RECEIPT DATE: 3/16/16 **ONSITE SEWAGE DISPOSAL SYSTEM** P 558037
 APPROVAL DATE: 6/20/16 **PERMIT: CONSTRUCTION** A _____
 PROPERTY ADDRESS: 11029 Blevins Drive
 SUBDIVISION: Blevins Property LOT: 5 TAX ID: _____
 CONTRACTOR: Hatfield's Equipment EMAIL: ken@hatfieldsequipment.com
 CONTRACTOR ADDRESS: P.O. Box 519, Annapolis Junction, MD 20701 PHONE: 301-480-4289

Re: Blevins Property
Lot 5
Septic System Design

SITE PLAN FOR BAT INSTALLATION

BLEWINS PROPERTY

See As-Built Drawing
On Separate Sheet

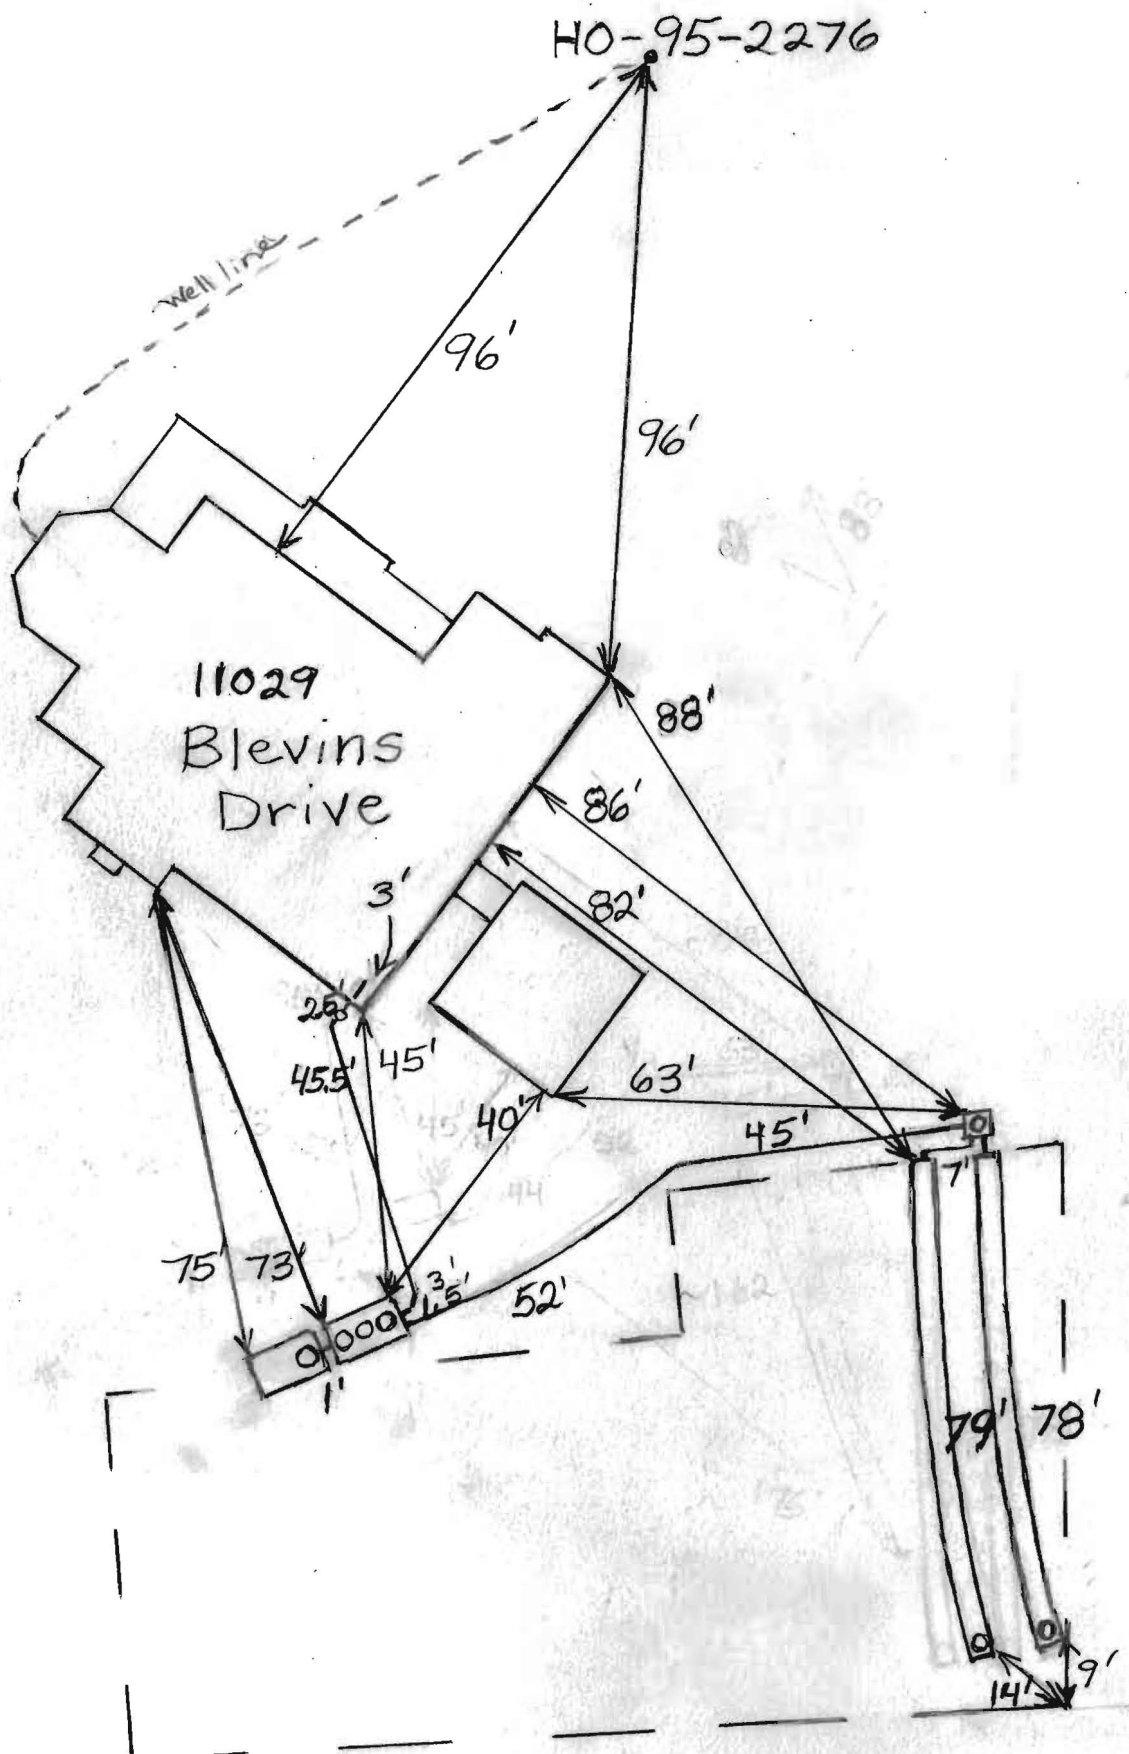
3/29/2016 Install trenches similar to plan. Location of house connection changed by plumber. Tank locations need to be changed. Builder gave the O.K. to set the tanks next to the bottom part of the septic easement. (BB)

Pump line installed. (BB)
4/1/2016 Trenches installed. Need BAT certification and pump and alarm test. (BB) 4/8/2016 Received Norweco certification from Back River Pre-Cast. Need pump and alarm test. (BB) 6/20/16 On site for pump + alarm. Alarm sounds, pump pumps effluent to D-box. (C) location from Back River Pre-Cast. (BB)

Blevins Property
Lot 5
November 11, 2015

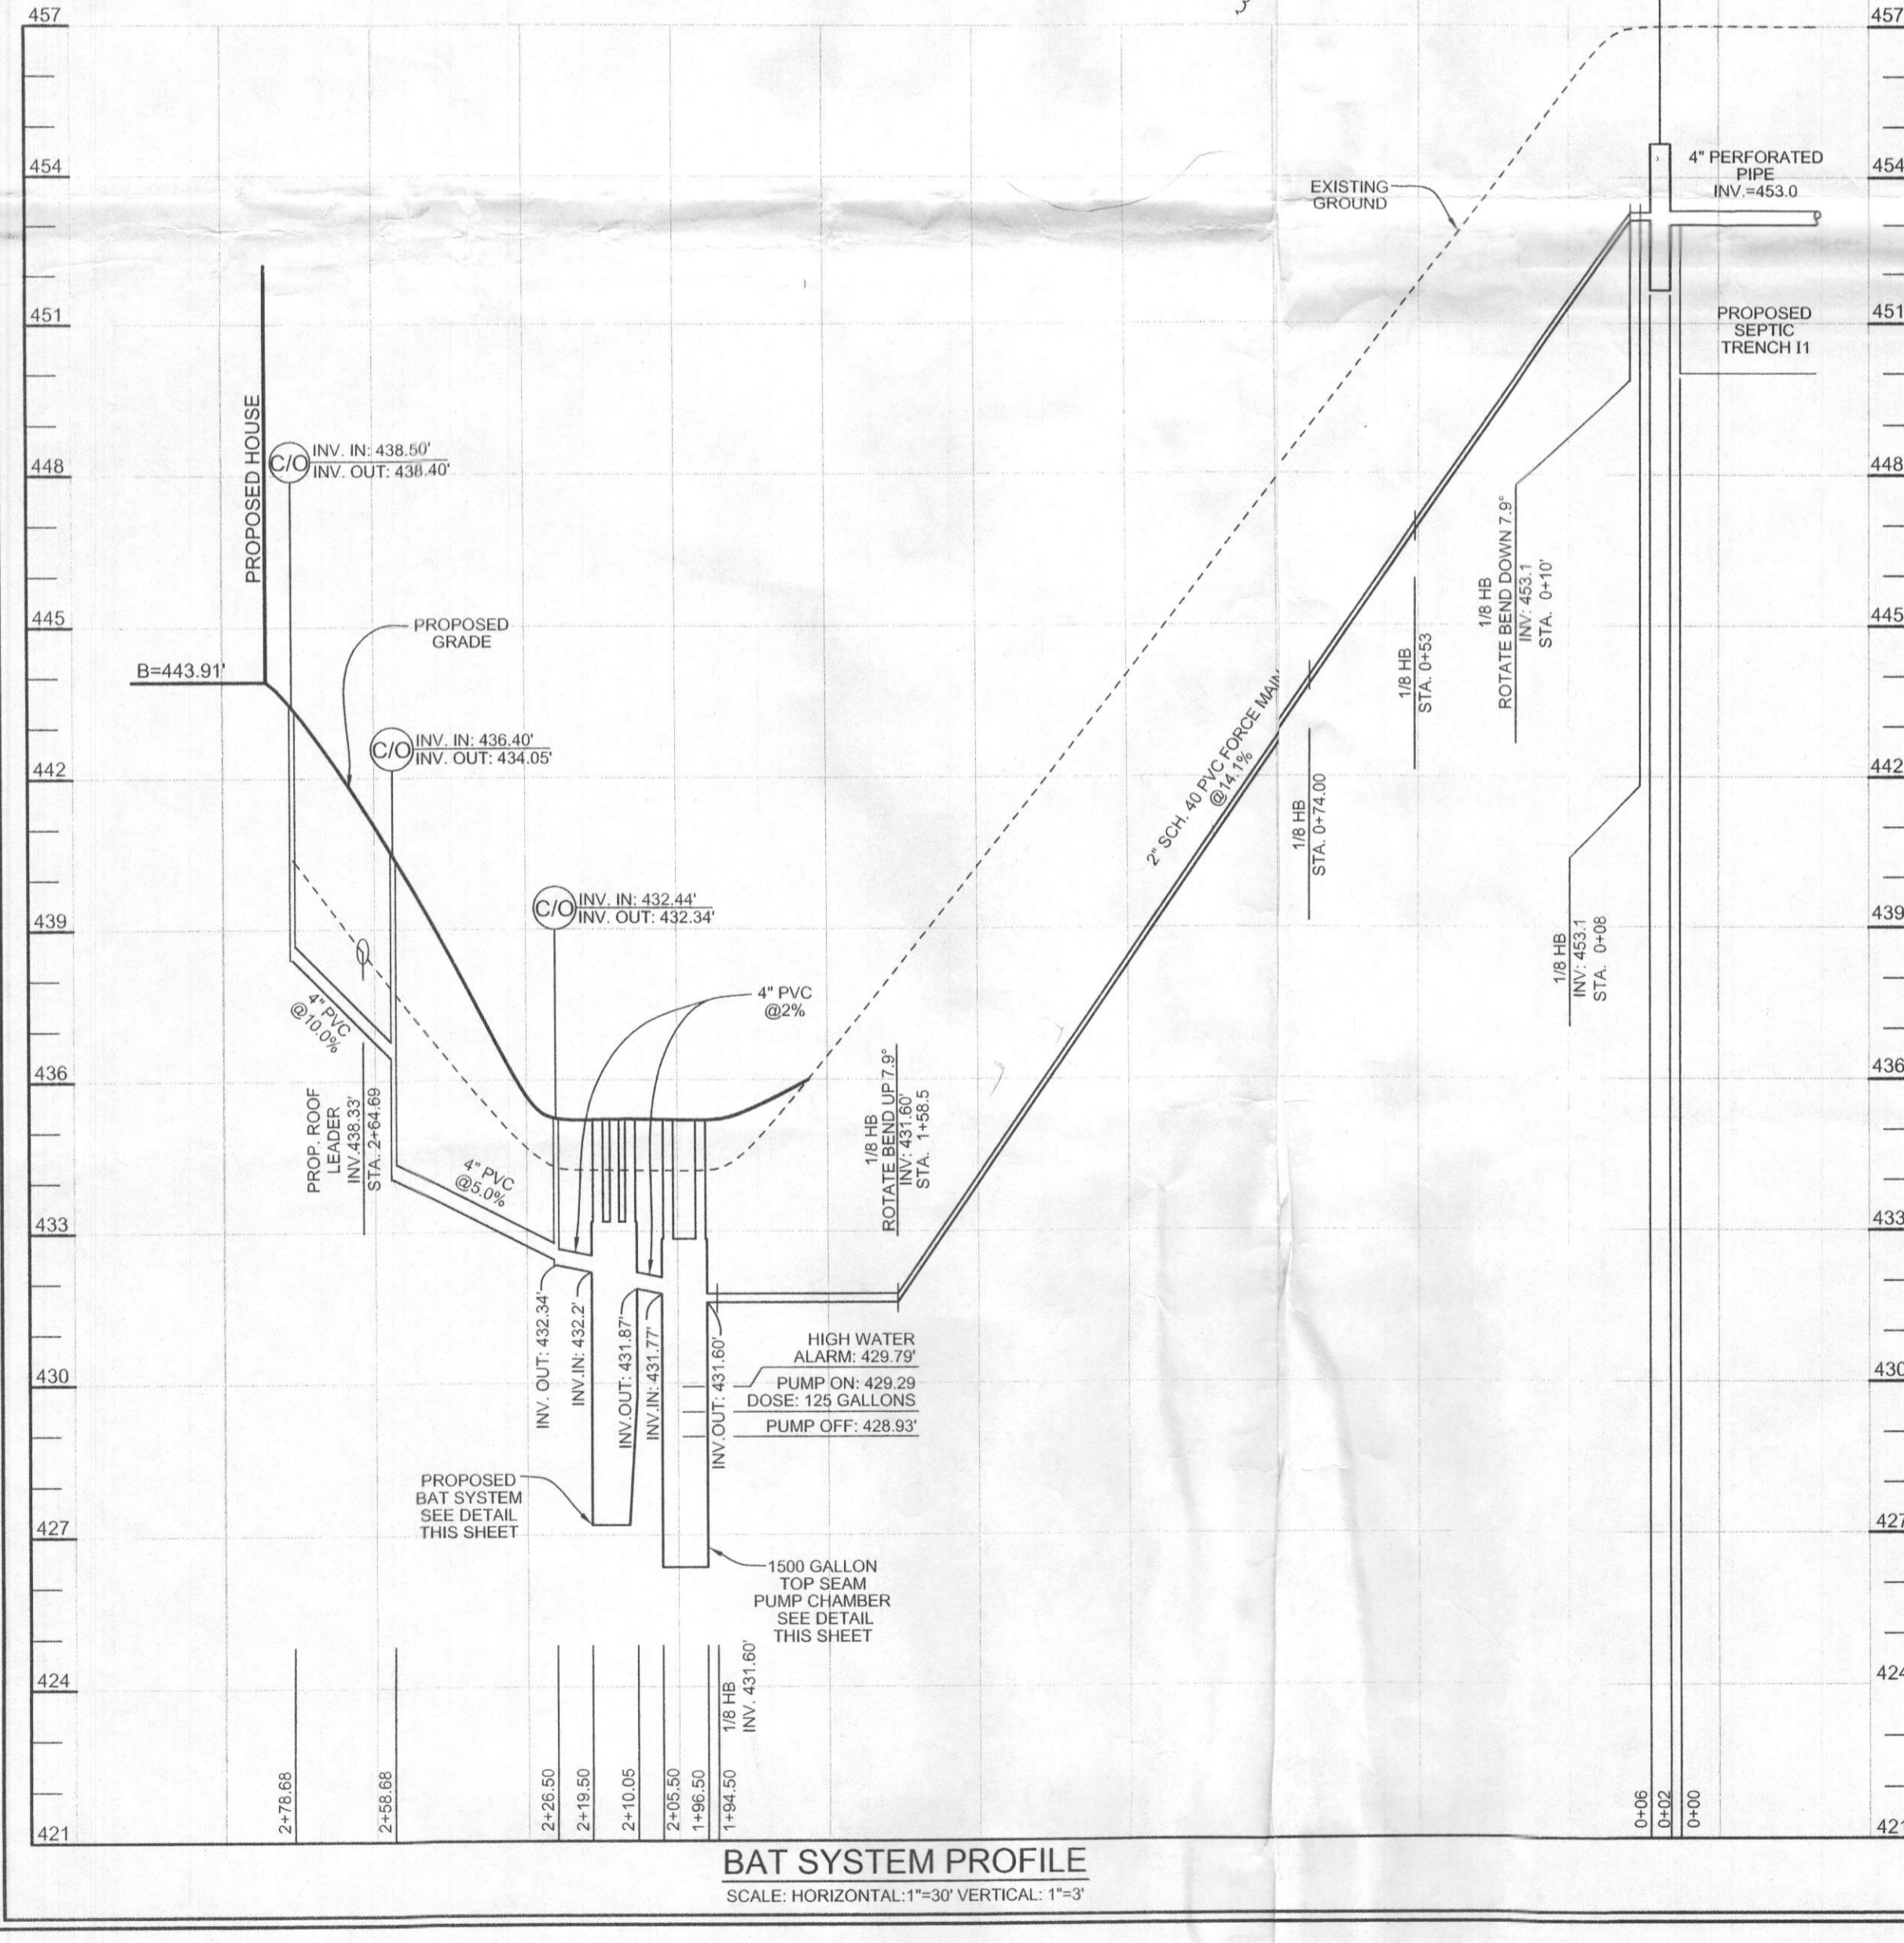
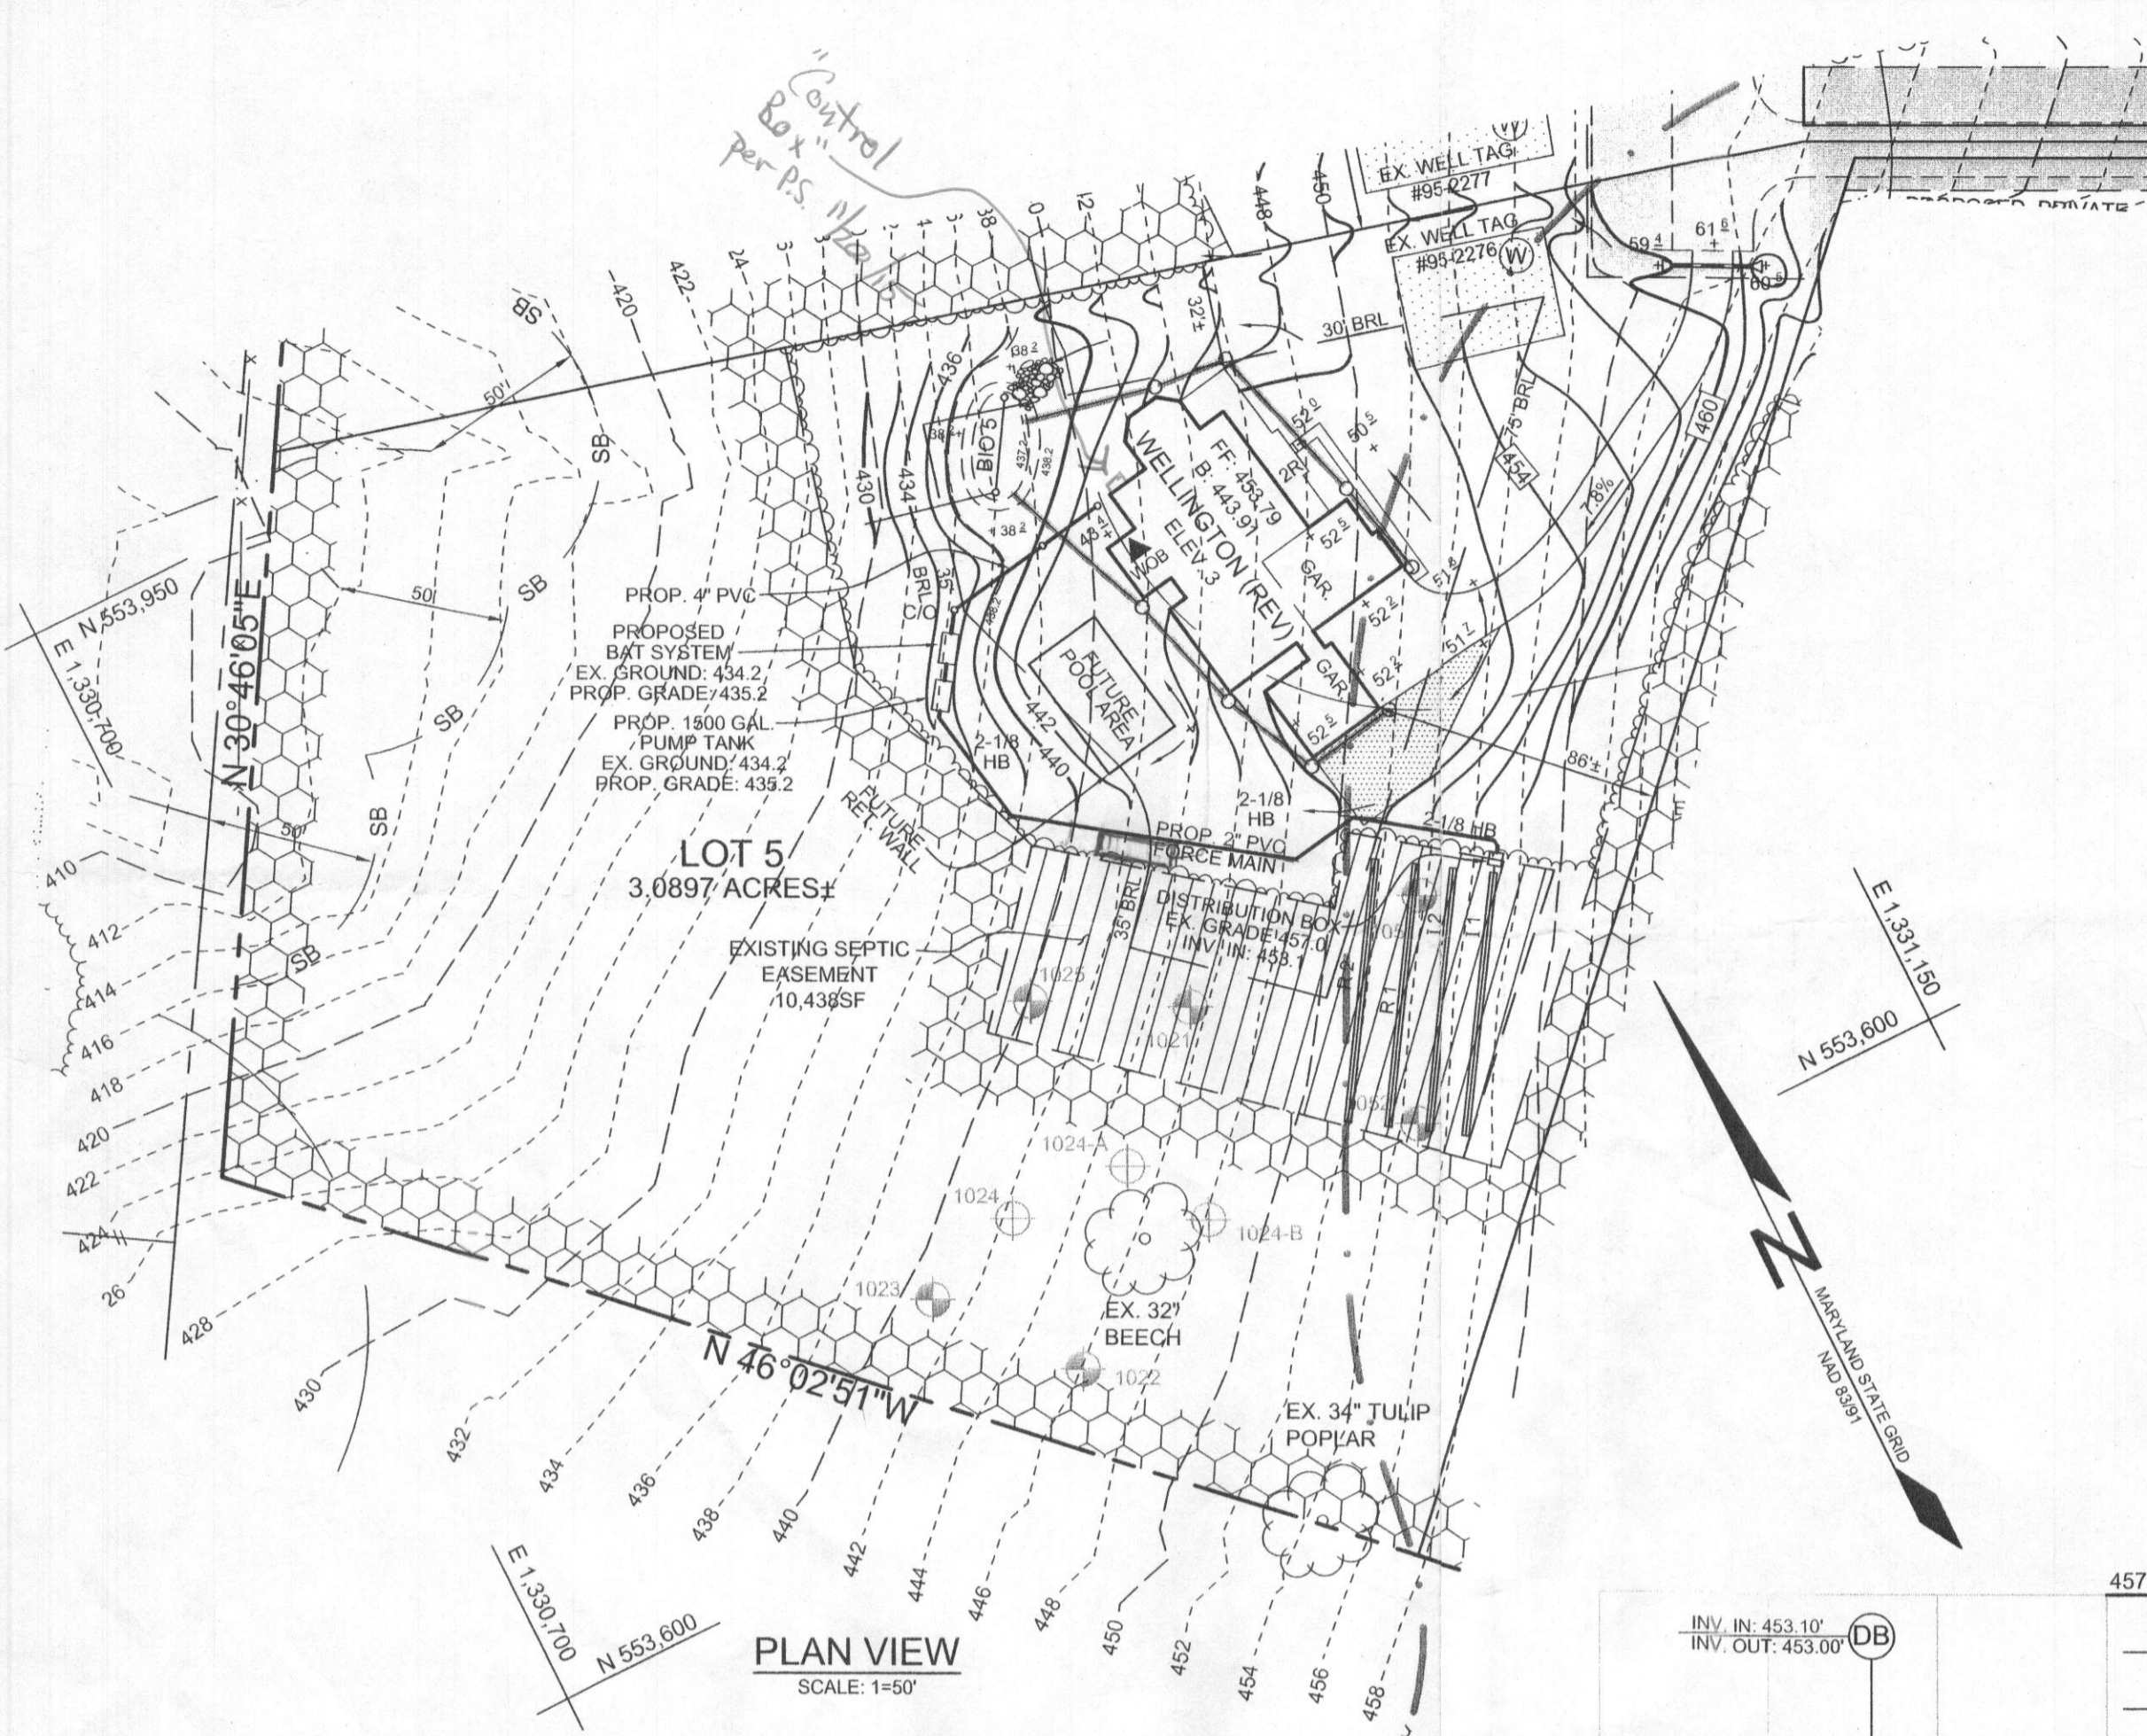
*u35 see response curve.
 OK vCB
 probably ~3.5 minutes*

- Total Dynamic Head = Static head + Distal Head + Friction head
- $25.9 + 2.0 + 3.7 = 31.6'$ use 32' *use 30' MB*
- Pump Chamber Design:
 - For pump tank dimensions and detail, see plans.
 - Pump chamber elevations:
 - Proposed grade at top of tank: 435.20'
 - Top of pump tank: 432.85'
 - Pump chamber invert in: 431.77'
 - High Water Alarm: 429.79'
 - Pump On: 429.29'
 - Pump Off: 428.93'
 - Bottom inside slab of tank: 426.68'
 - Pump Chamber volumes:
 - Pump On to Pump Off: 16.49 cf or 123.38 gallons
 - Excess (High Water Alarm to top of tank): 125.07 cf or 935.62 gallons
